Edmundson Plaza

Development Special
Use Permit #2006-0023 (A)

Planning Commission Meeting
June 5, 2007

REQUEST: Consideration of a request for approval of: 1) a development special use permit, with site plan for an office building with ground-floor retail and underground parking; 2) a special use permit for a Transportation Management Plan; 3) a special use permit for an increase in the penthouse height; 4) a special use permit for increased floor area; 5) a special use permit for a health club; 6) a special use permit for a restaurant use; and 7) a vacation of a portion of the public right-of-way on Reineker's Lane.

Figure 5: Building Separation

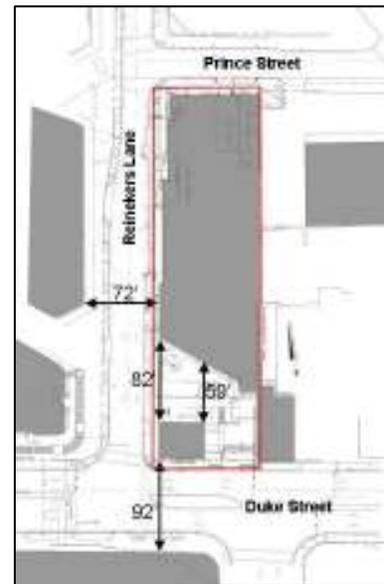
- Provide a considerable (59 to 82 ft) setback between the two buildings;
- Step down the building height in the direction of the historic building;
- Provide ground level open space and landscaping around the historic building;
- Use appropriate wall treatment adjacent to the historic building; and
- Use modulation, materials and colors to reduce the perceived scale of the proposed building.

(see Figure 5). The distance is significant, and is comparable to the 66-foot width of a typical Old Town street (building-

Figure 16: Proposed Open Space

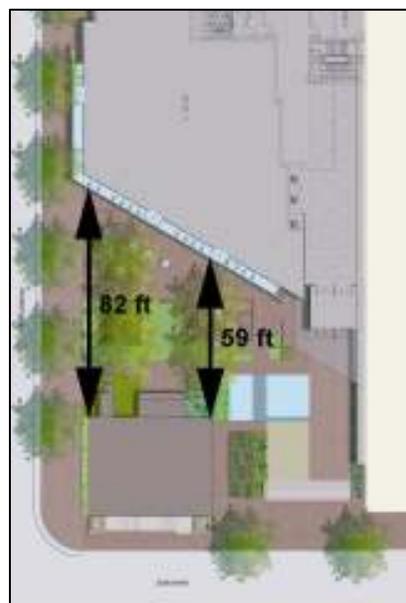
With the multiple purposes and opportunities of this open space courtyard in mind, staff has included recommendations to enhance its quality, to make the open space area more compatible with the existing and proposed buildings, and to provide an appropriate memorial to the historic site. These changes include:

- Increasing the amount of landscaping and trees in the open space area to form a courtyard around the historic building;
- Requiring that the open space/courtyard area consist of a portion with lawn or planted area;
- Creating an appropriate gathering area and memorial within the courtyard area to commemorate the solemn history of this site, such as a fountain or sculpture;
- Creating a clear separation between the courtyard area and any outdoor activity space of the new office building so that such things as outdoor dining can coexist harmoniously with the memorial area; and
- Requiring final design approval of the open space courtyard and memorial by BAR.

Figure 20: Setback Modifications

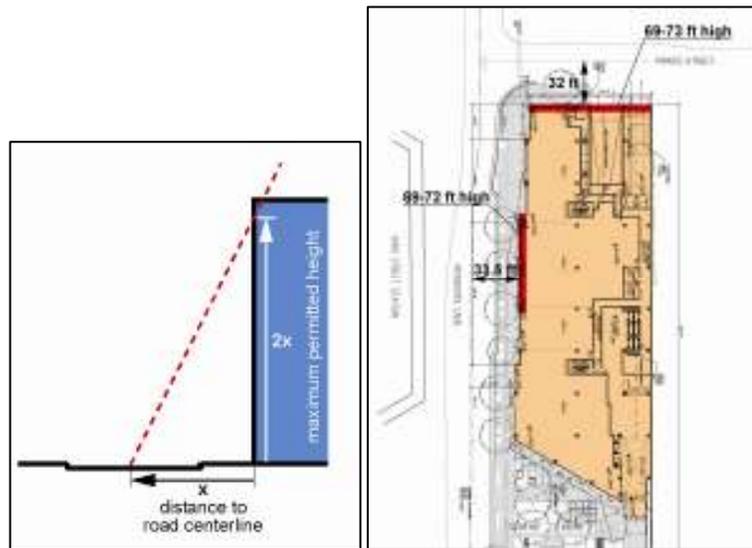
Although the OCH zone does not have yard requirements, the Zoning Ordinance requires that the building be set back from the centerline of the street it faces a distance equal to at least half the height of the building at every point. In this case, one key factor warrants a modification of this technical requirement along Prince Street and a portion of the building along Reineker’s Lane. The early Metro development of the King Street Station Shops complex and the building at the intersection of Diagonal and Daingerfield Roads “shifted” the roadway at this location resulting in an offset alignment of the road.

The height of the building along Prince Street varies due to the grade change of the street sloping down about four feet from the intersection of Reineker’s Lane to the eastern edge of the property. Along Prince Street, the proposed building varies in height from 66 to 70 feet, with a setback of 32 feet from the centerline. The setback rule requires a setback of 33 to 35 feet, resulting in a requested modification of 1 to 3 feet. Along Reineker’s Lane, the portion of the building that does not meet the setback requirements is 72 feet tall with a 33.5-ft. setback from the centerline. The setback rule requires a 36-ft. setback from the centerline of Reineker’s Lane, and therefore a 2.5-ft. modification is required.

Figure 21: Health Club Floor Plan

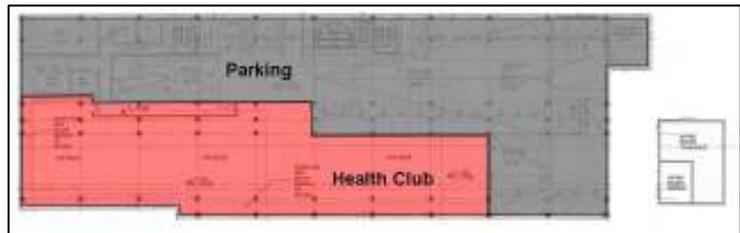
The proposal includes a 12,000 sq. ft. health club within the first underground level of the building. The health club use is permitted with an SUP within the OCH zoning district. Although the health club counts toward the on-site parking requirements for this development, the below grade space devoted to the use is not included in the overall floor area ratio calculation since it is below grade. The applicant is unable to supply sufficient detail regarding the use, such as the operator, hours, and type of health club, for staff to be comfortable with the use at this preliminary point. Unlike a restaurant, whose characteristics are well known, even given variations in some features, health clubs can vary significantly as to peak times, and especially as to parking requirements, depending on the detailed proposal and operator. Staff therefore recommends that the health club use not be approved with this development permit. Rather, it should be considered for approval as a separate SUP, pending more information regarding the applicant, number of employees, number of required parking spaces, and how the parking will be accommodated.

12. The proposed health club use shall require subsequent special use permit approval by the Planning Commission and City Council. (P&Z)
13. Exhaust vent shafts and grease traps shall be located within the retail space to accommodate the ground floor restaurant uses. (P&Z)
14. Professional offices may be permitted in the designated retail spaces but shall occupy no more than 50% of the gross floor area and shall be located on the Prince Street and Reineker's Lane portion of the building. (P&Z)
